IV. PRELIMINARY PLAT REVIEW

The following review is based upon the submitted application and accompanying plan titled, "Revised Preliminary Plan of: Wendemere Subdivision Section Two (Waycross)," prepared by Croft Engineering Company, dated 7/12/2013; Sheet No. 1 of 1.

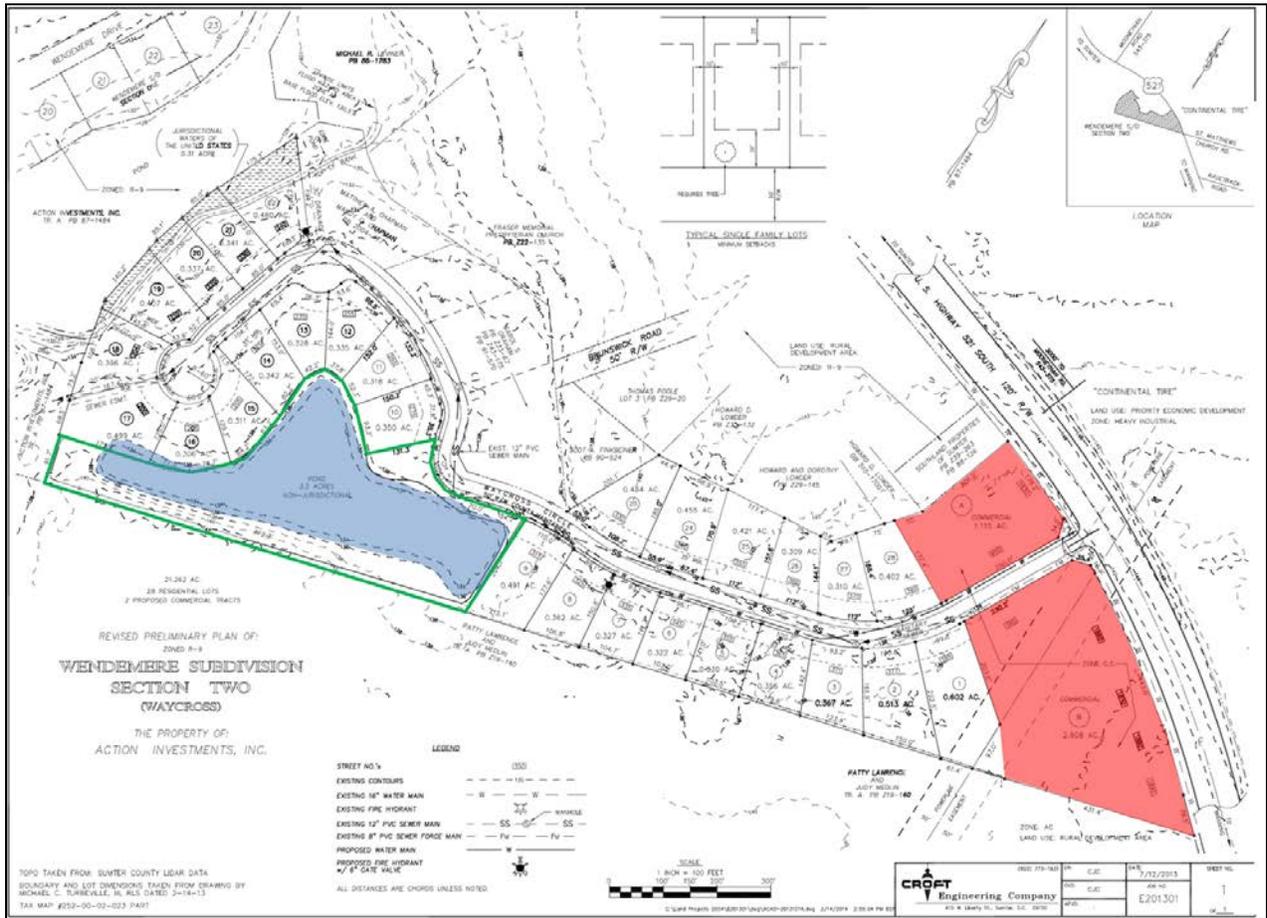
The average lot size in this development is 0.39 acres with lots ranging in size from 0.306 acres up to 0.602 acres. All lots meet the minimum lot width of 75 ft. at the minimum building line and are within the required residential width to depth ratio requirement of 1:2.5. Each parcel has enough buildable area to meet all minimum setback standards without exceeding the maximum 40% impervious surface ratio.

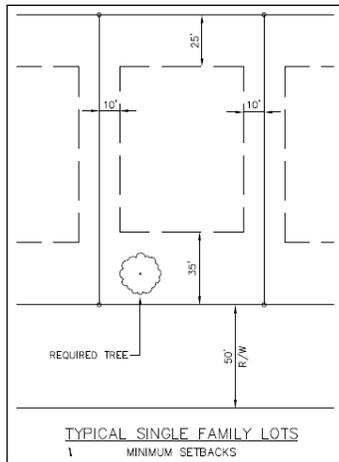
As shown in the graphic above, the area highlighted in red has been designated for commercial development and insulates that residential area from the impacts of the Hwy. 521 South Corridor. The applicant has indicated that improvements to the street entrance and signage at Hwy. 521 South will be addressed at a later date prior to development of the commercial area. Staff is agreeable to this request based on existing site conditions.

A landscape plan has not been submitted to address the existing stormwater pond, highlighted in green in the graphic above. Currently, there is a substantial tree line between the pond and the adjacent agricultural tract to the south. Staff recommends the applicant submit a landscape plan that addresses the frontage on Waycross Circle

As shown on FEMA FIRM Panel 45085C0477D, Effective Date: 2-16-2007, the property is influenced by the AE flood zone as shown in the graphic to the right.

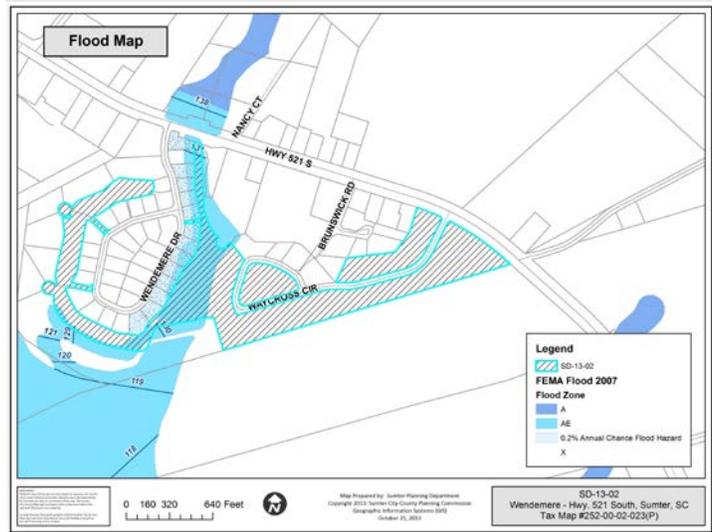
Based on review of the Preliminary Plat, there are five (5) proposed parcels (Lots #s 18, 19, 20, 21, and 22) with floodplain present at the rear of the parcels. The location of the floodplain leaves sufficient developable area for construction outside of the floodplain, however; plot plans showing the floodplain boundary and location of any fill will be required prior to permits for construction on the above referenced lots.

In addition, the applicant has indicated that the same area is Jurisdictional and subject to review and permitting with the US Army Corps of Engineers (USACE). An updated permit from USACE will be required prior to final plat approval.
